## Report to Sydney Central City Planning Panel

<b>SWCCP reference</b>	2018SWC003
<b>DA No.</b>	1008/2017
<b>Date of receipt</b>	8 December 2017
<b>Proposal</b>	<p>Concept Development Application in accordance with Section 4.22 of the Environmental Planning and Assessment Act 1979 (EPA Act) for the restoration and refurbishment of the Roxy Theatre and associated forecourt, including part demolition at the rear section of the site and a 33 storey building envelope for a commercial building.</p> <p>The part demolition and restoration of the Roxy Theatre is for the purpose of accommodating a range of uses including an entertainment facility, a function centre and commercial premises.</p> <p>The proposal is Integrated Development requiring approval under the Heritage Act 1977 and the Water Management Act 2000.</p>
<b>Street address</b>	65-69 George Street, Parramatta
<b>Property Description</b>	Lots 1 and 2 in DP 76080
<b>Applicant</b>	K Capital Group c/- Urbis Pty Ltd

<b>Recommendation</b>	Refusal	
<b>Report by</b>	SJB Planning - planning consultants to City of Parramatta Council

Figure 2: Figure prepared by OEH identifying site line control overlaid onto DA 1008/2017. View looking west along George Street, with red dotted line projected from eye height standing on footpath.

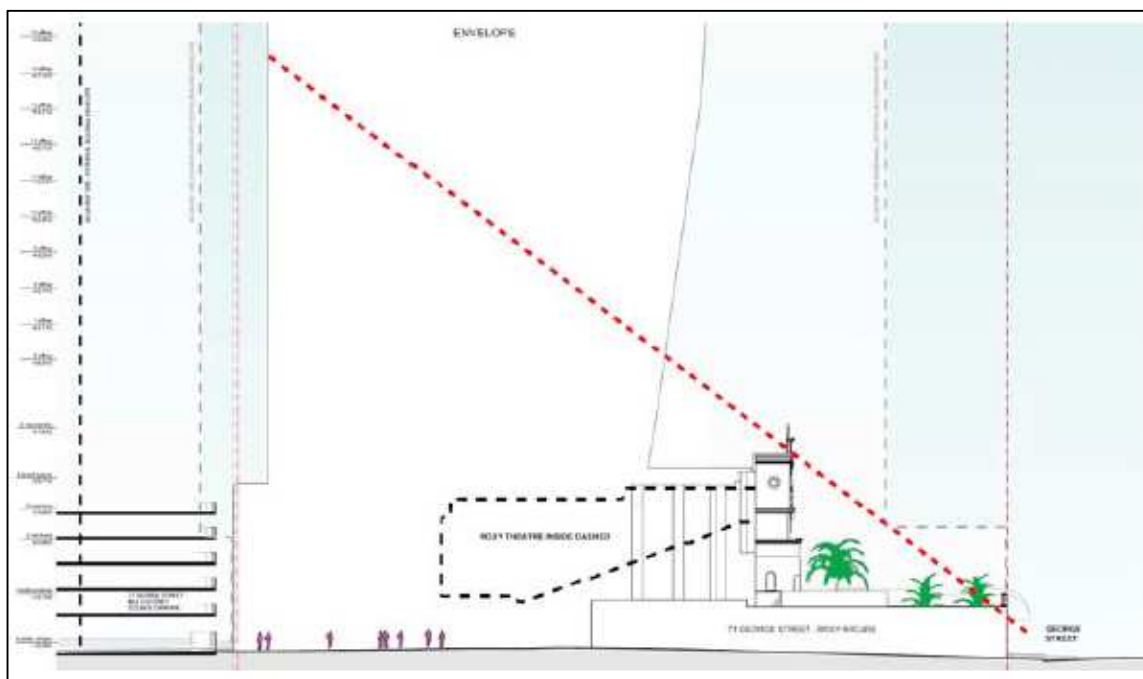
The Heritage Council has provided an indication of the scale of envelope at the rear of the site that may be acceptable, which would result in any tower having a maximum height of approximately half of that currently proposed – and significantly less than that closer to the parapet element of the existing building (refer Figure 2 below).
